MEMORANDUM: REMAND - LOCAL MAP AMENDMENT

DATE: April 14, 2006

SUBJECT: **Local Map Amendment No. G-836:** J. Kirby Development, LLC and Vedanta Center of Greater Washington seeks reclassification of 16 acres of land from the RE-2 zone to the PD-2 zone for 20 single family detached residences (one existing), 12 single family attached residences and 6 townhouse units (MPDU) and expansion of an existing worship center. Proposed rental units for senior independent living were deleted from the proposal. Located at intersection of Bel Pre and Homecrest roads. Aspen Hill Master Plan.

Initial Development Scheme - G-836

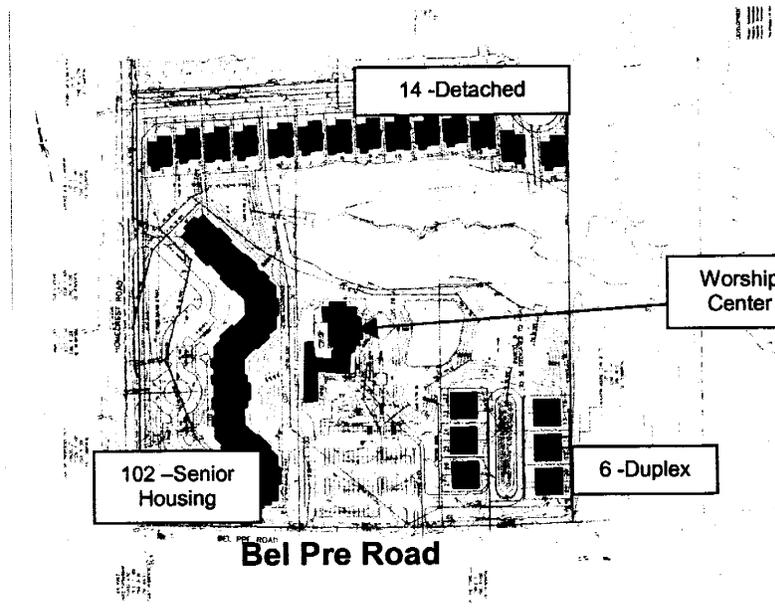
maximum one third of tract for calculating the bonus, per 59-C-7.14(d)(3)(c)². The original submission would have located another large building at an intersection where the Aspen Hill Master Plan specifically identifies a concern for over concentration of large-scale institutional uses.

The relationship of the various components of the original proposed development was tenuous at best and ignored objectives of the PD zone purpose clause. The only link was the required sidewalk on public roads. The various components were compartmentalized on the plan increasing access points and making sharing of parking a challenge.³ In order to accomplish this scheme, a PD-7 classification would be necessary when the plan only allows PD-2. While the plan calls for a road on the north side of the property, the single loaded configuration was thought by staff to be inefficient. Such a suburban and auto-oriented design is not inconceivable in the PD zone. However, staff suggested that instead it was possible a better design could go further to advance the purpose clause objective to, “encourage a maximum of social and community interaction among those who live and work within an area. Staff believes that limited effort was taken to, “Create a distinctive visual character and identity for each coordinated residential use.” No internal pedestrian connections or open space linked the site. The applicant made several efforts to resolve these matters with the senior housing component but then decided to drop that aspect of the proposal and redesign.

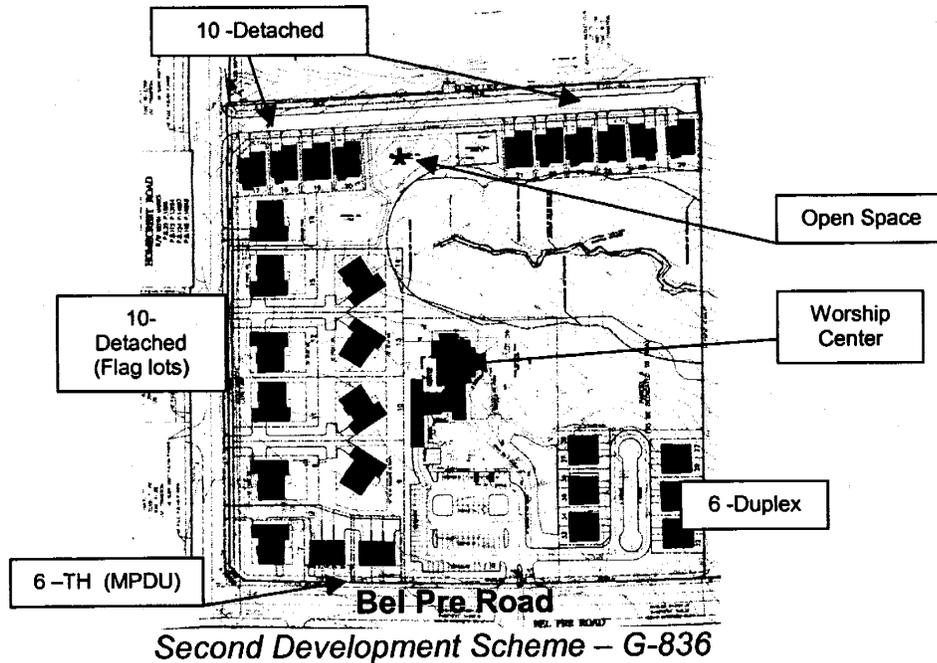
³ A link to promote shared parking between senior housing and the worship center is clearly a missed opportunity considering the parking deficit for senior housing and surplus for the worship center.

Having eliminated the senior housing, the next draft represented a fundamental improvement, in that the zone requested was PD-2. This brought the scheme into master plan conformance for density. Staff continued to argue for better social and community interaction as called for in the PD zone purpose clause. The open space area and some internal paths represented an improvement. Staff continued to object to the way the disparate assembly of the plan and was particularly concerned with the use of flag lots on Homecrest. Staff asked the applicant to provide internal pedestrian connections and work to integrate the worship center into the development. Subsequent to hearing various staff and community concerns, the applicant presented the current draft.

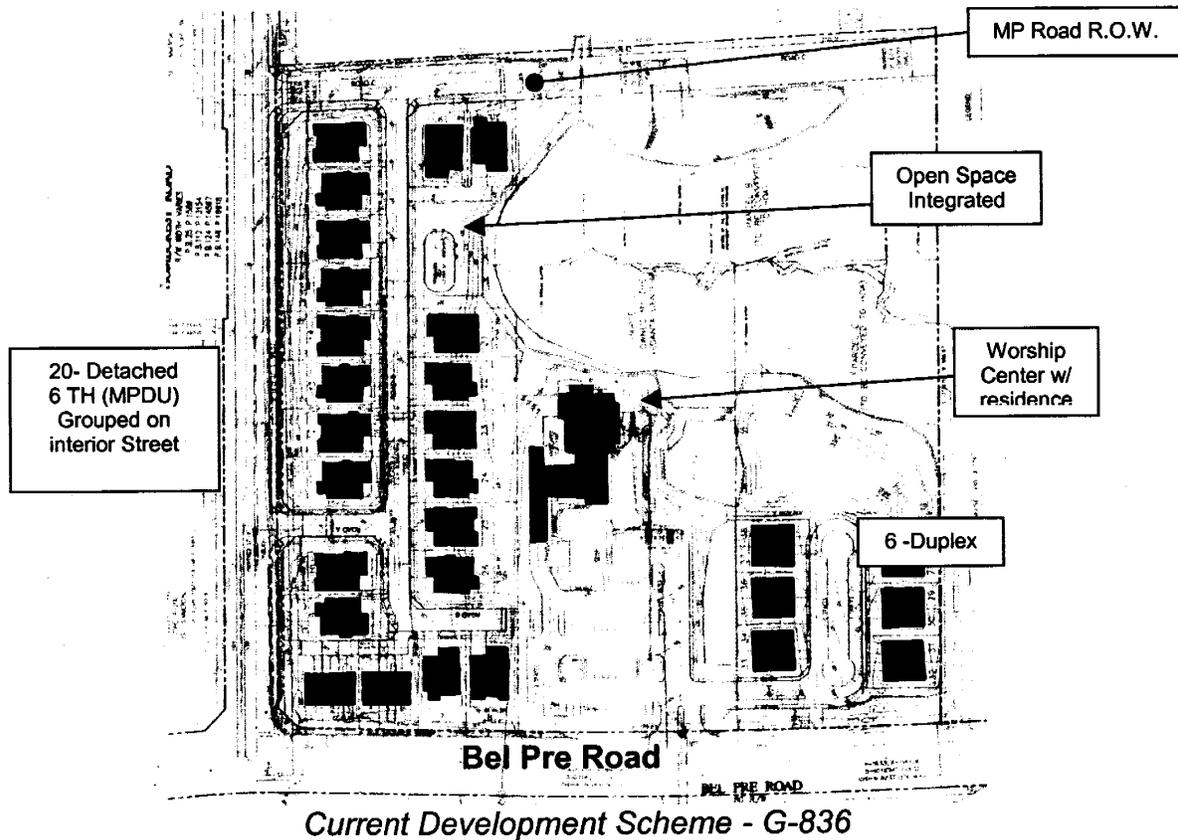
The current scheme has many favorable components. Most of the residential development has been grouped in a pattern that encourages interaction off the main roads and “creates a place” that has an identity. Reinforcing this is an open space feature incorporated prominently into the interior development. While grouping of MPDUs can be a detriment, the small size of this development with environmental constraints leaves few options. While the MPDUs are not interspersed, they are integrated with the market rate units. Pedestrian connections link the worship center and related duplexes to the rest of the community. An emergency connection is available connecting the worship center to the interior street. Should roads be blocked, this provides emergency vehicles an option but the design prohibits cut-through in normal situations.

The master plan road on the north of the property is retained in this design, mostly as a dedication. Considering the uncertainties for development of the adjacent property, construction may not yet be necessary. Further consideration of this matter will be given when the preliminary plan of subdivision is reviewed. The scheme permits further discussion of the new intersection at Homecrest during preliminary plan review.⁴
